# Access Compliance Report

## Public Rights-of-Way

| Intersection ID: 13352                  | Main Street: S_ALEXANDER_ST | Cross Street: E_STONEWALL_ST            | Location: SW           |
| ADA ID: 6FDEC9AAD0D3                    | Ramp Type: ParaDiag         | Initial Pass/Fail: Fail                 | Overall Compliance: No |

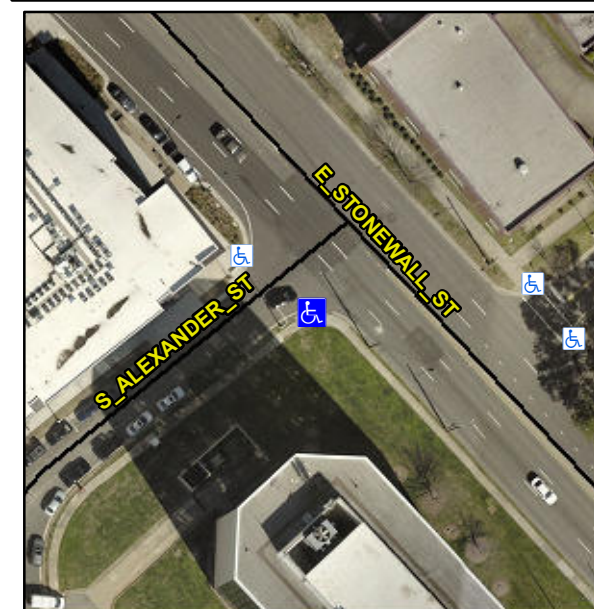
**RT RP < 5%**

**R304.3.2, R304.5.3**

| Compliance | Description          | Data  | Compliance | Description                 | Data  |
|------------|----------------------|-------|------------|-----------------------------|-------|
| No         | Ramp Slope LT (%)    | 9.4   | Yes        | Ramp Slope RT (%)           | 3.5   |
| No         | Ramp XSlope LT (%)   | 2.8   | Yes        | Ramp XSlope RT (%)          | 1.9   |

**Remove & Replace Curb Ramp With Two New Directional Ramps or Equivalent.**
